**HISTORIC PRESERVATION BOARD STAFF REPORT**

**824 E Atlantic Avenue**

Meeting	File No.	Application Type
August 7, 2024	2024-180	Certificate of Appropriateness

The item before the Board is consideration of a Certificate of Appropriateness (2024-180) for a partial exterior color change on a contributing commercial structure located at **824 E. Atlantic Avenue, Marina Historic District.**

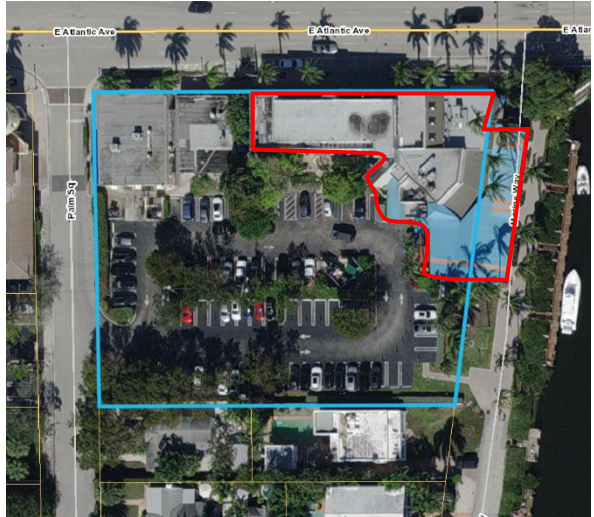
In 2021, the east portion of the three-story existing structure was painted to match the Deck 84 portion of the site. The owner did not receive approval from the city for repainting this portion of the building (see photo below).

Standards 2, 3, and 5 are applicable to the request. There is concern with regard to Standards 2, 3, and 5, as the fluted pilasters on the side of Deck 84 (see image below) have been painted the same beige hue as the walls of the structure, the muted designs along with the wall color difference from the rest of the building giving the illusion that these are separate structures and diminishing the architectural detailing of the building. This method of painting a structure is not typical as it creates a conjectural design which is not recommended for an historic structure as it does not fully communicate the style and detailing of the Art Moderne architecture.

In order to protect the building’s distinguishing character and the pilaster elements, which contribute to the visual character of the Art Moderne building design, the pilaster elements should be painted the same color, consistently across the span of the façade (not the same color as the wall facades). Consideration could be given to painting the walls of the structure one consistent color in order to protect the character and simplicity of the Art Moderne style building. However, it could be seen appropriate for the one-story portion of the structure and with the associated glass façade to remain as they exist.

With respect to **Relationship of Materials and Color** the subject proposal consists of painting the walls beige (Sherwin Williams-“Stucco” 7569) with doors and trim to be painted a crème color (Sherwin Williams-“Natural Choice” 7011). Portions of the building where the Deck 84 restaurant exists will remain a separate darker beige color. There is concern with regards to the request as the structure as a whole should be painted in its entirety and not in sections to accommodate the different businesses. Doing so diminishes the architectural detailing of the Art Moderne building causing disharmony and color clashes. Also, it is recommended that all design features and trim be painted an accent color different from the body color in order for the pilaster elements to remain visible and prominent features of the Art Moderne design of the structure.
